# HISTORIC AND DESIGN REVIEW COMMISSION

**HDRC CASE NO:** 2022-103  
**ADDRESS:** 112 COLLEGE ST  
**LEGAL DESCRIPTION:** NCB 405 BLK 22 LOT 3 THRU 8  
**ZONING:** D, HS  
**CITY COUNCIL DIST.:** 1  
**LANDMARK:** Individual Landmark  
**APPLICANT:** OMNI LA MANSION CORPORATION  
**OWNER:** OMNI LA MANSION CORPORATION  
**TYPE OF WORK:** Tree removal and patio modifications  
**APPLICATION RECEIVED:** February 09, 2022  
**60-DAY REVIEW:** Not applicable due to City Council Emergency Orders  
**CASE MANAGER:** Rachel Rettaliata

## REQUEST:

1. Remove three (3) palm trees.
2. Install new lighting.

## PATIO OVERVIEW

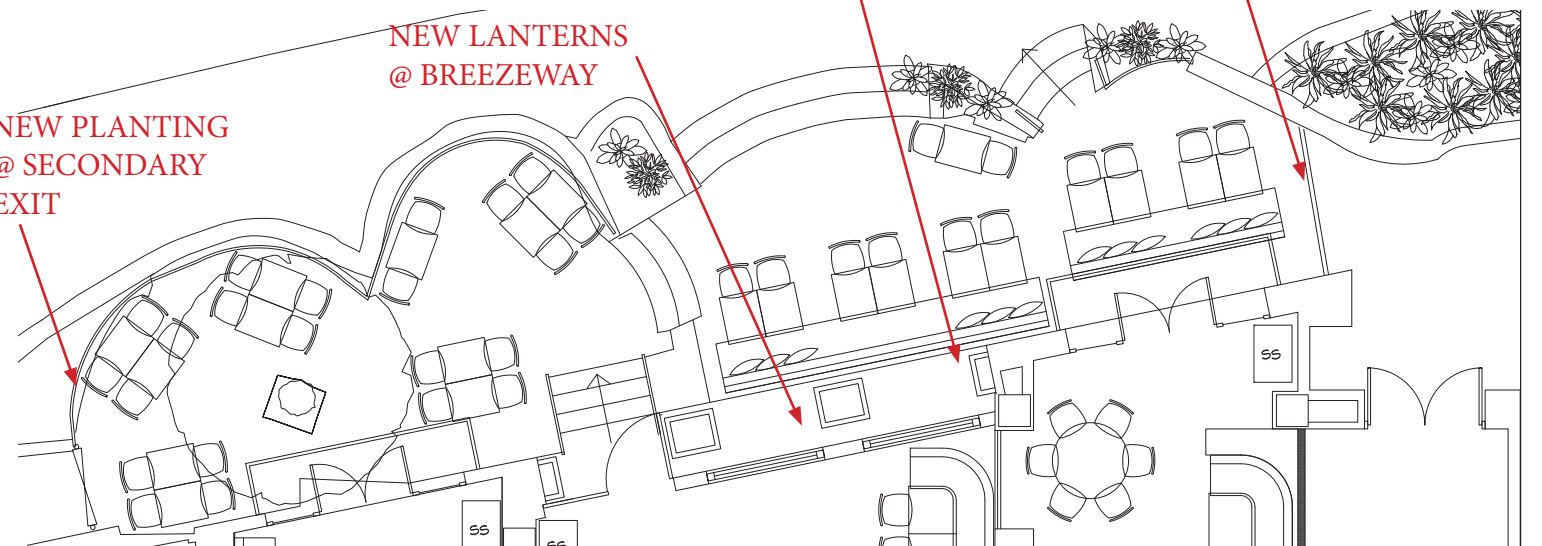
- c. TREE REMOVAL – The applicant has proposed to remove three (3) palms along the Riverwalk at 112 College to accommodate patio modifications. The existing palm trees were likely planted as mature palms in 1979.

- e. According to the City Arborist, the palms proposed to be removed meet the significant/heritage definition. If the permit is approved for removal of the palms, mitigation will be required. There is also a Live oak tree within the area that will likely be heavily impacted. Based on the extent of impact to the root system of the tree there may be mitigation requirements for the oak tree as well. Tree review and inspection has not been completed by the City Arborist.

- f. LIGHTING – The applicant has proposed to install three (3) new lanterns in the each archway where the palms are currently located. Staff finds the proposal appropriate.

Staff recommends approval of the proposed plan as recommended by the City Arborist with the following stipulation:
